Replat—Lots 1 & 16 Harrison Hills—Streck, Inc.

CITY OF LA VISTA
PLANNING DIVISION
RECOMMENDATION REPORT

CASE NUMBERS: PRP20-0002;

RE: Harrison Hills Replat 7 – Initial Review Letter

FINAL
PLAT

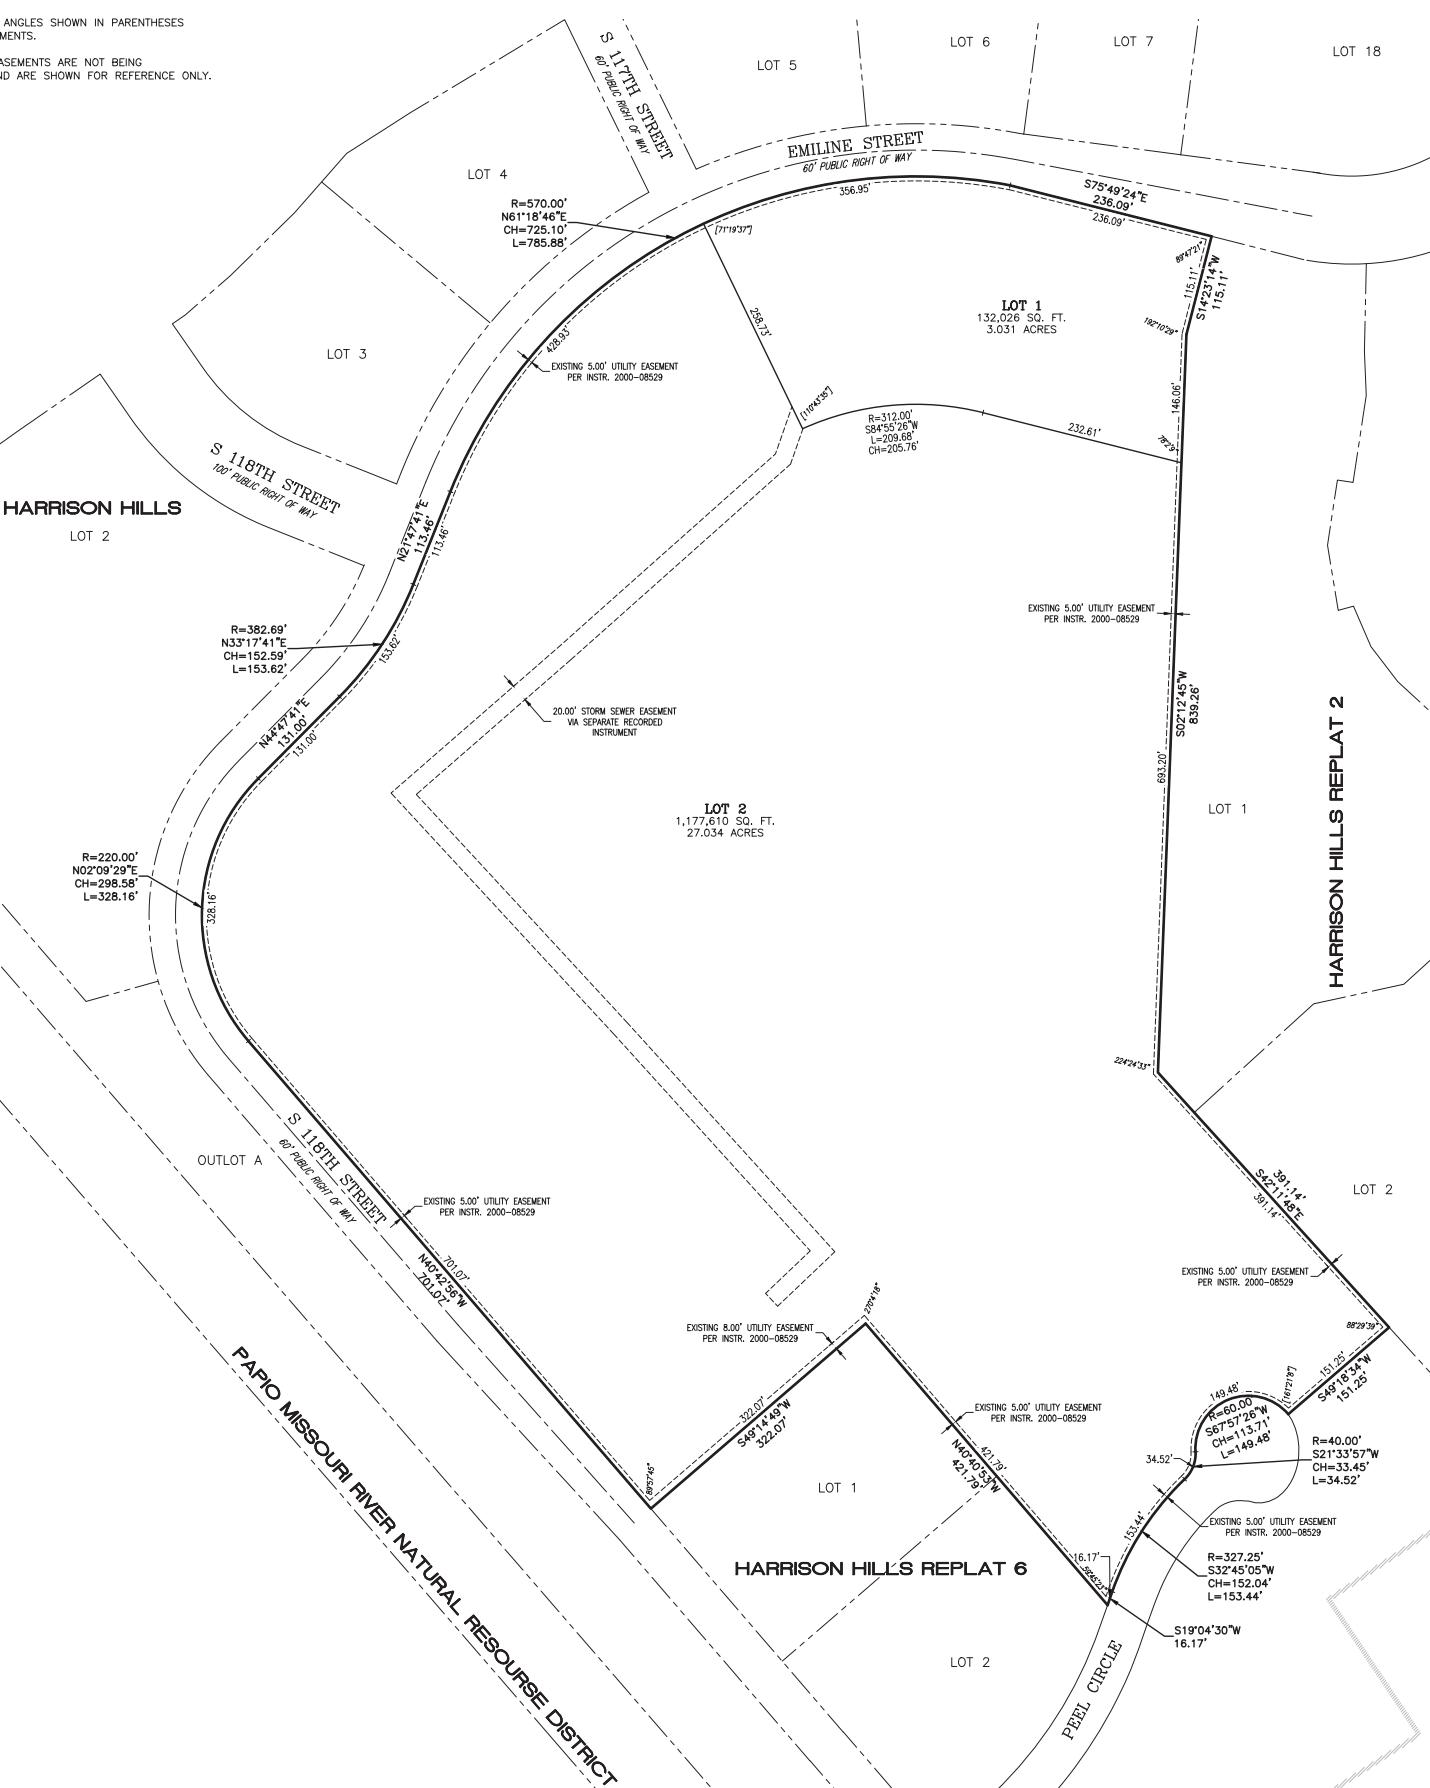
8. Section 3.07.03, Section 3.03.15 – The legal description needs to include total acreage involved in the plat.

11. Section 3.07.03, Section 3.03.18 – Please clarify if there is a lien holder for the property involved in the plat. If so, the Lien Holder Consent block shall be added to the Final Plat.

Response: The total acreage is included in the legal description on both the preliminary and final plat exhibits.

Response: There is no lien holder on the property.
